Access Compliance Report

Public Rights-of-Way

(Curb Ramps)

Intersection ID: 28395	Main Street: BRIDGEHAMPTON CLUB DR	Cross Street: CHATSWORTH CT	Location: NE
ADA ID: 4049A728AD30	Ramp Type: BlendTrans2	Initial Pass/Fail: Fail	Overall Compliance: No
		Severity Score: 8.75	
Codes/Mitigation Info/Possible Solution		Field Measurements/Component Compliance

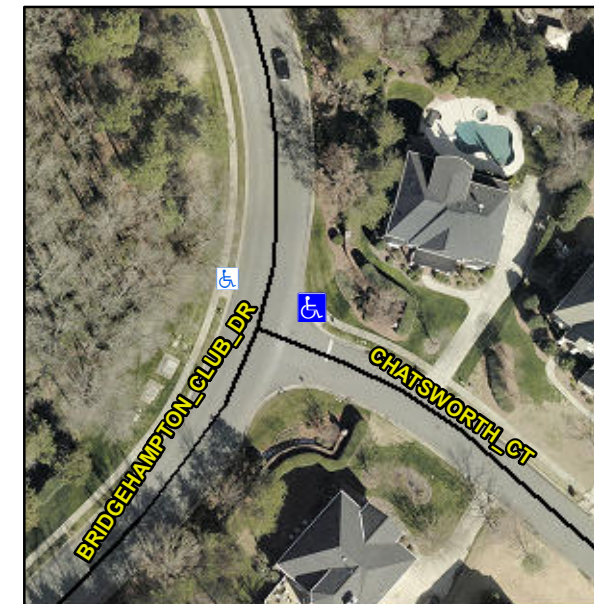
Not Found, R304.5.1

Compliance	Description	Data	Compliance	Description	Data
N/A	Ramp Length (in)	96.0	Yes	BlendTrans Slope (%)	3.1
No	Ramp Width (in)	38.5	Yes	BlendTrans XSlope (%)	0.1
N/A	Flare Type LT	N/A	N/A	Flare Type RT	N/A
N/A	Flare Slope LT (%)	N/A	N/A	Flare Slope RT (%)	N/A
N/A	Flare Traversable LT?	N/A	N/A	Flare Traversable RT?	N/A
N/A	Landing Length (in)	N/A	N/A	DWS Provided?	N/A
N/A	Landing Width (in)	N/A	N/A	DWS Contrast?	N/A
N/A	Landing Slope (%)	N/A	N/A	DWS Length (in)	N/A
N/A	Landing X Slope (%)	N/A	N/A	DWS Full Width?	N/A
N/A	Landing Curb? (Y/N)	N/A	N/A	DWS Offset (in)	N/A
N/A	Shared Landing?	N/A			
N/A	Gutter Ponding?	N/A	N/A	Gutter Slope (%)	N/A
N/A	Gutter Lip Ht (in)	N/A	N/A	Gutter X Slope (%)	N/A
N/A	Painted X Walk1?	No	N/A	Painted X Walk2?	N/A
	X Walk 1 Direction	To NW		X Walk 2 Direction	N/A
	X Walk 1 Width (in)	N/A		X Walk 2 Width (in)	N/A
	X Walk 1 Slope (%)	6.3		X Walk 2 Slope (%)	N/A
	X Walk 1 X Slope (%)	0.0		X Walk 2 X Slope (%)	N/A

N/A	Ramp inside XWalk1?	N/A	N/A	Ramp inside XWalk2?	N/A
	Road Slope (%)	0.0		Clear Space?	N/A
	Road X Slope (%)	6.3	N/A	Clear Space to XWalk (in)	N/A
N/A	Any Obstructions?	N/A	N/A	Storm Grate/Utility Hazard?	N/A
	Obstruction Type			Storm Grate/Utility Type	
		N/A			N/A
			Yes	Surface Condition? (G/P)	Good
			No	Curb Slope (%)	32.8

Remove & Replace Curb Ramp With Two New Directional Ramps or Equivalent.
